File 1994-0043

Name: Wal-Mart Expansion – Site Plan Review – 2879 North Avenue

TITLE HEADING: Site Plan Review - Wal-Mart  
Expansion

FILE: #43-94  
DATE: March 17, 1994  
STAFF: Kathy Portner  
REQUEST: Wal-Mart Expansion--Site Plan Review  
LOCATION: North Avenue and Melody Lane  
APPLICANT: Dunaway Associates West, Inc.

**PLANTING PLAN**

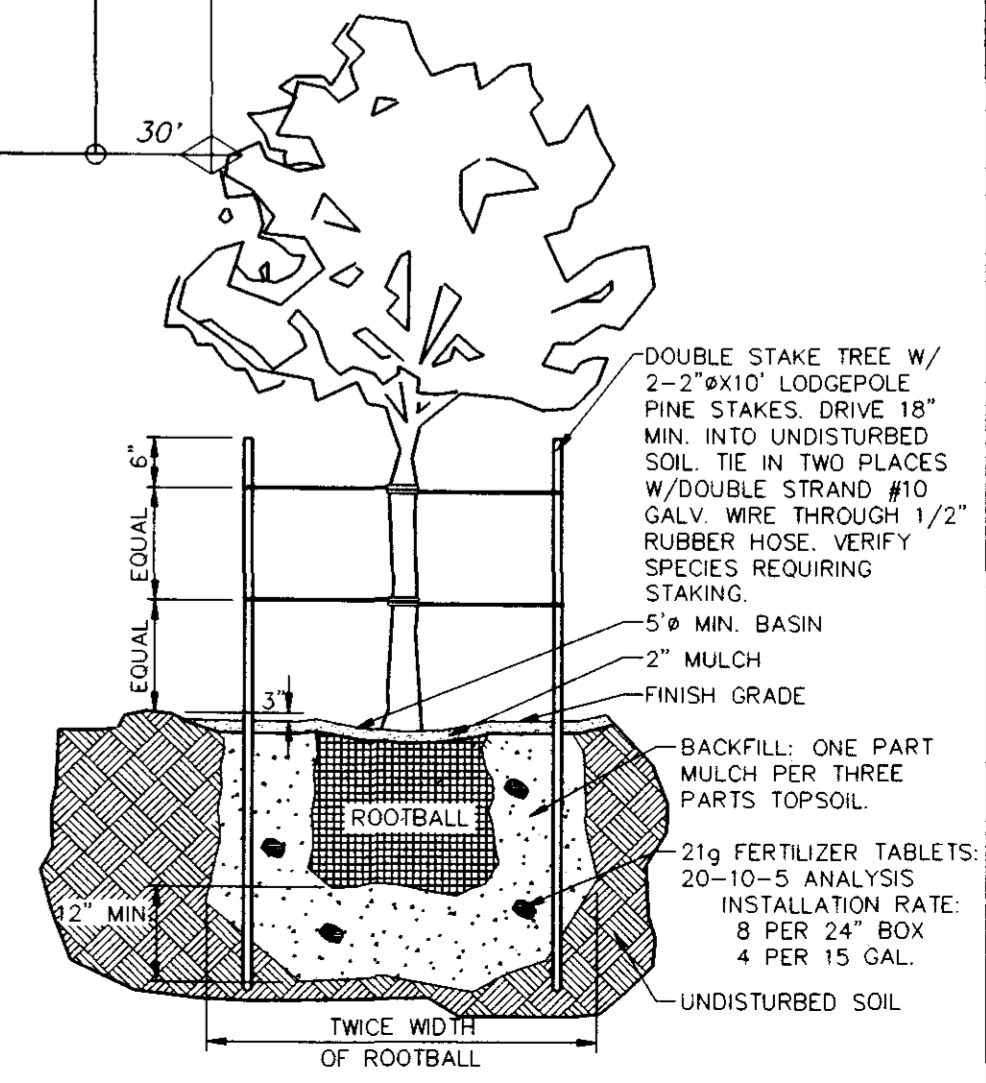
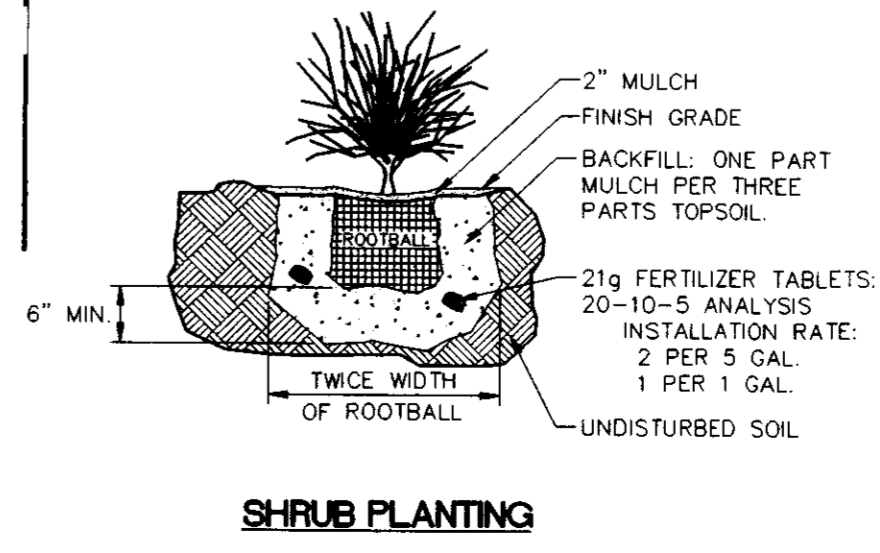
Rough estimate (scaled from drawing) of landscaping provided	10,040
	1,440
50 trees shown - 4 trees to west of bldg that will be removed w/ future expansion <del>are</del> excluded = 46 trees	2,340
	75
	3,530
7 additional trees required - to be placed in parking islands with no trees shown	2,610
	370
	15,300

2. Show on the plans the square footage of all existing and/or proposed landscaped areas. It appears the site does not meet the current landscaping requirement of 75% of the first 15' along North Avenue, 75% of first 10' along Melody Lane and 5% of the total parking area. Landscaping shall include 40% shrubs and one tree for every 500 sq. ft. (or fraction thereof) of landscaped area. Interior landscape islands will be required in the parking lot.

You will also note that the plan meets or exceeds your comments with regard to landscaping and the installation of curbed planter islands as mentioned by Jodi Kliska.

NO. DATE: 6-1584 ADD. 7 TREES IN PARKING LOT PER CITY OF G.J.
